TRANSMITTAL OF DEFENSE NUCLEAR FACILITIES SAFETY BOARD (DNFSB) RECOMMENDATION 2010-2 IMPLEMENTATION PLAN (IP) DELIVERABLE 5.1.3.2

**CONTRACT NO. DE-AC27-01RV14136 – WTP RESPONSE TO CRESP REVIEW
TEAM LETTER REPORT 7 - PJM VESSELS**

WTP RESPONSE TO VULNERABILITIES IDENTIFIED BY PACIFIC NORTHWEST NATIONAL LABORATORY (PNNL)

Figure 1 Aluminum Mass per TFCOUP 6 Batch (Figure 4.1-1 of 2008 WTP Tank Utilization Assessment)

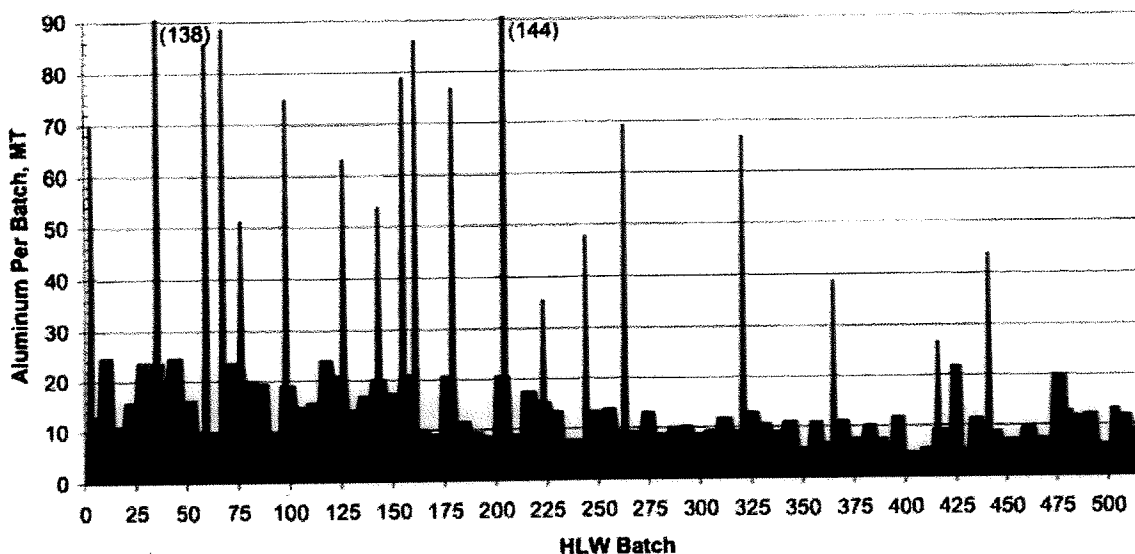
- The amount of aluminum in the expected waste feeds is shown in Figure 1 on page 8.
 - The breakdown of aluminum constituents in the expected waste feeds is depicted in Figure 2 on page 9.

Figure 3 Caustic Leach Time in UFP-2A Batches (Case 2 - Boehmite) (Figure 3.1-1 of 2010 WTP Tank Utilization Assessment)

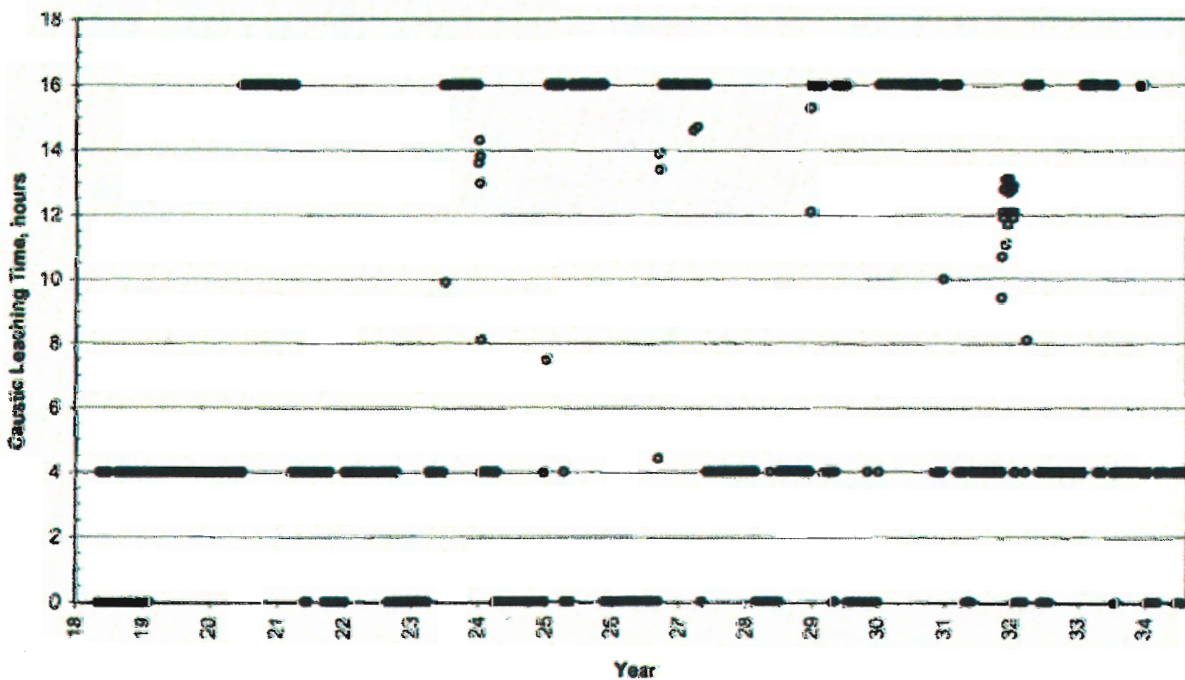
- Each small circle on Figure 3 on page 9 is a Vessel UFP-2A batch. Several small circles clustered together appear as a line in the figure. The left axis is the leach time performed for the batch. Batches requiring just gibbsite leaching or no leaching are shown at or below the 4-hour line. Batches requiring boehmite leaching are shown above the 4-hour line. Batches between the 4-hour and 16-hour lines were successfully leached to produce the minimum HLW glass mass. Batches residing on the 16-hour line did not have sufficient leach time to produce the minimum HLW glass mass.

Figure 4 Aluminum Leached (Case 2) (Figure 3.2-6 from 2010 WTP Tank Utilization Assessment)

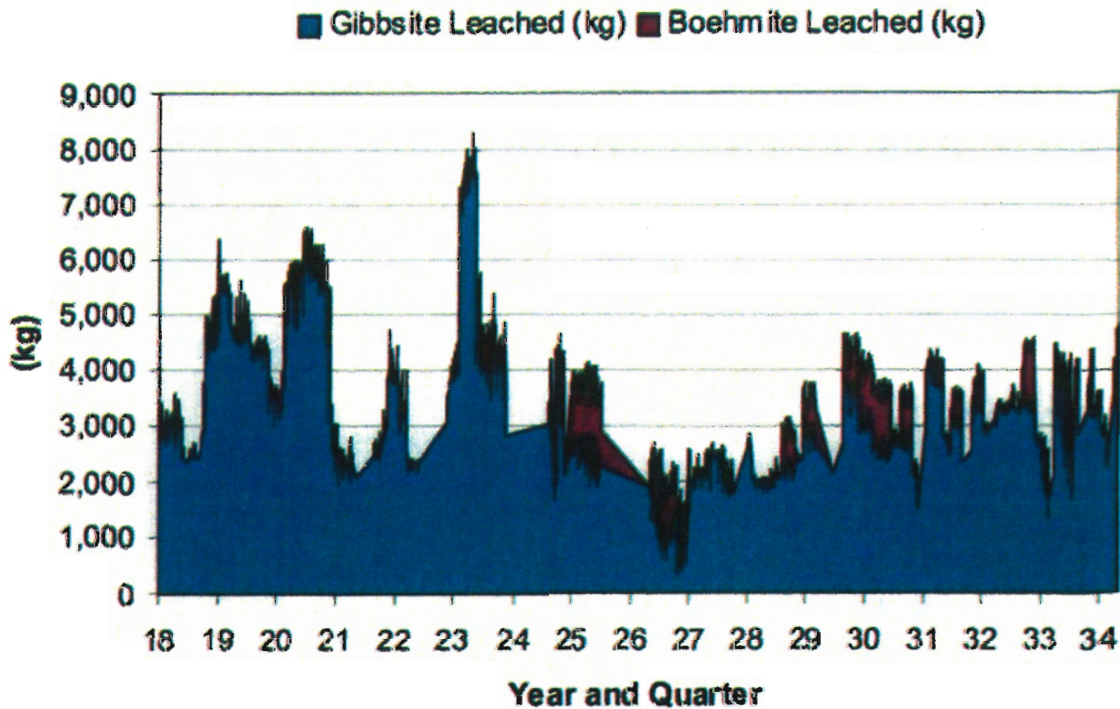
- Figure 4 on page 10 shows the amount of aluminum leached for each batch of waste.
 - *WTP Tank Utilization Assessment* (24590-WTP-RPT-PET-10-020, Rev. A).

Figure 5 HLW Glass Limiter and Waste Loading (Case 2 - Boehmite) (Figure 3.4-4 of 2010 WTP Tank Utilization Assessment)

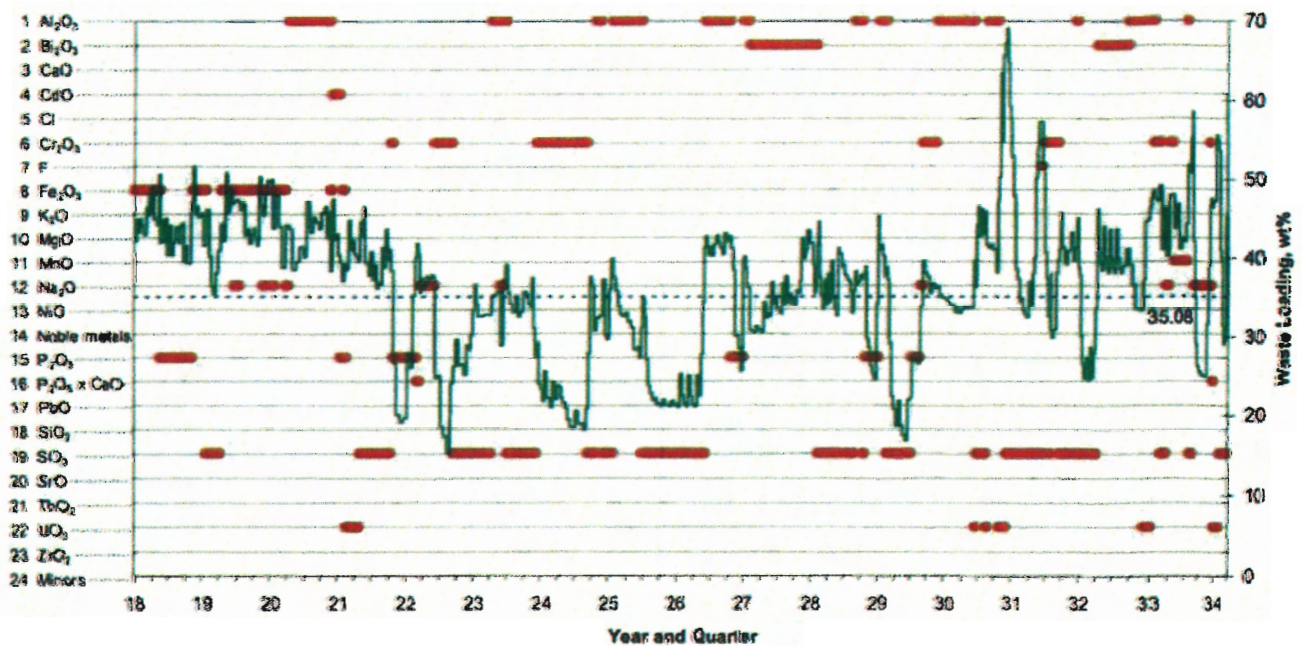
- Figure 5 on page 10 provides the waste loading in HLW glass (in green) and the limiting waste constituent in each load (in red).
 - *WTP Tank Utilization Assessment* (24590-WTP-RPT-PET-10-020, Rev. A).
